## Bayview Avenue Area Study – Final Report

<b>Date:</b>	October 15, 2007
<b>To:</b>	City Council
<b>From:</b>	Chief Planner and Executive Director, City Planning
<b>Wards:</b>	Ward No. 23 – Willowdale
<b>Reference Number:</b>	File No. 05 18990 TM

Staff report for action – Final Report – Bayview Avenue Area Study

Attachment 1: Bayview Area Study Guidelines

FIGURE 3

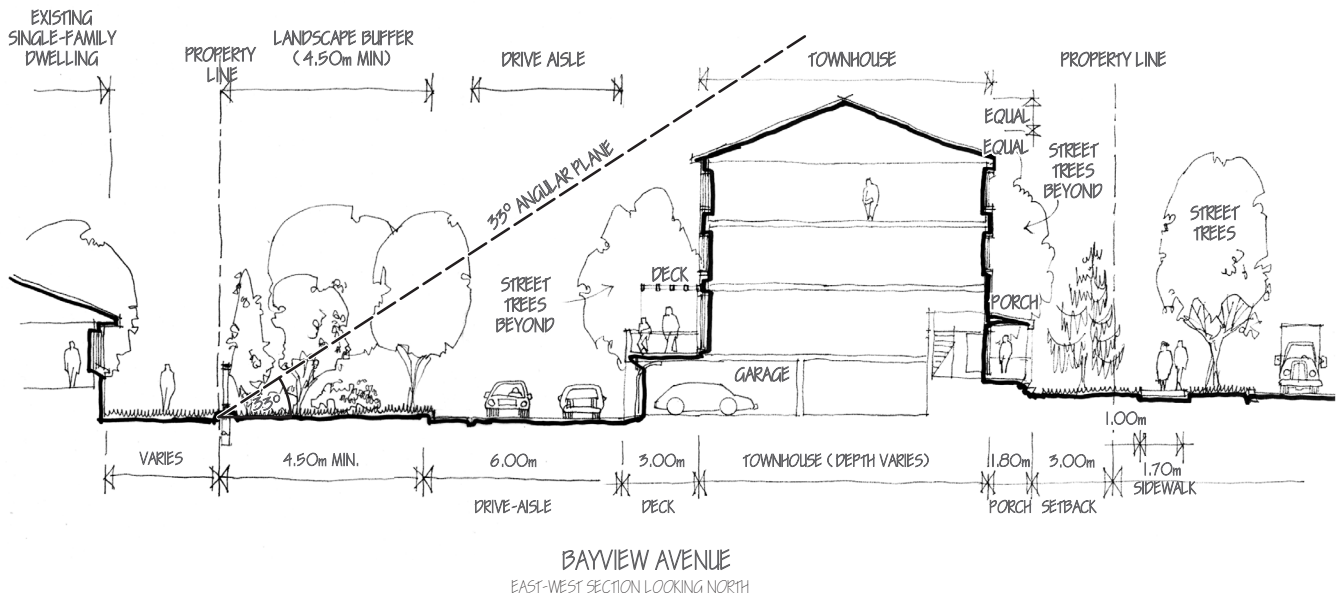
2. In order to further clarify the height and setback requirements for ‘Scenario A’, a 33 degree angular plane has been illustrated on Figure 3. The 33 degree angular plane is similar to the 70 percent of the horizontal distance requirement outlined in the Guidelines. Figure 3 has also been reconfigured to better illustrate the height limits of both the transitional dwellings and the townhouse dwellings.

1. The guidelines have been amended with respect to Transition ‘Scenario A’ (page 2) to read as follows:
  - No part of any building shall exceed 70 percent of the horizontal distance separating that part of the building from the nearest residential property line;

- A rear yard setback not less than 9.5 metres shall be provided;
  - There will be a suitable opaque barrier 1.8 metres in height, as well as a minimum 4.5 metre landscape strip to buffer the adjacent low density residential neighbourhood from the potential impacts of redevelopment.

FIGURE 5

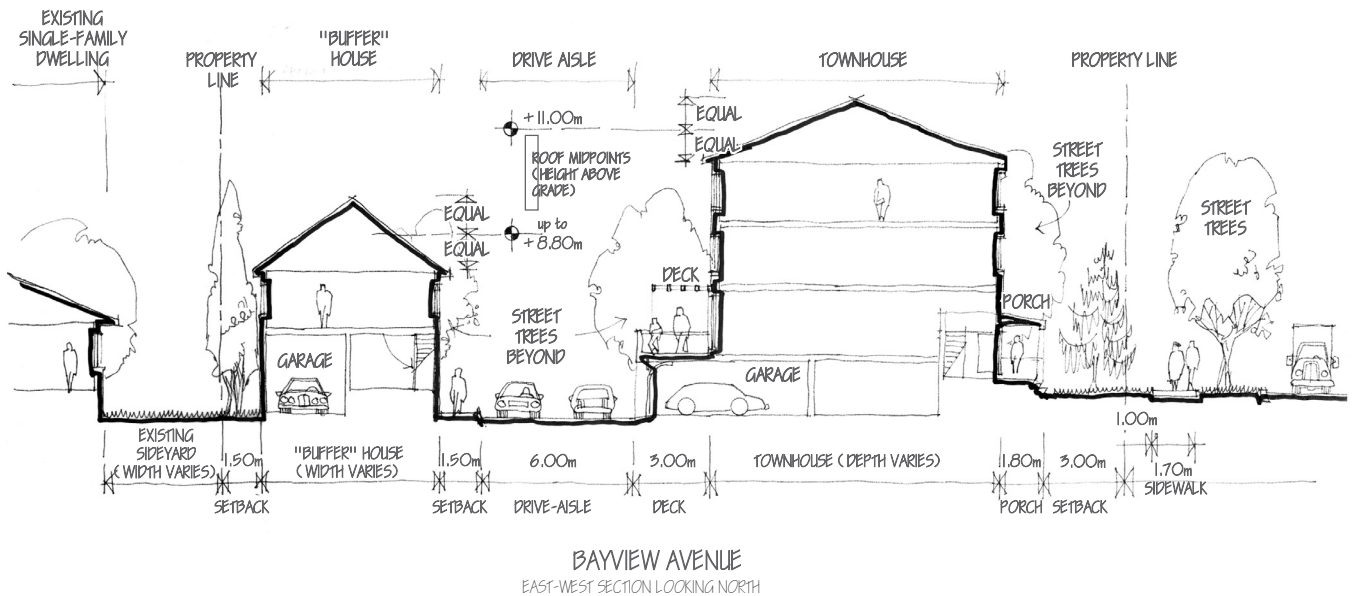
3. Figure 5 ‘Scenario B’, has been reconfigured to better illustrate the height limits of both the transitional dwellings and the townhouse dwellings.
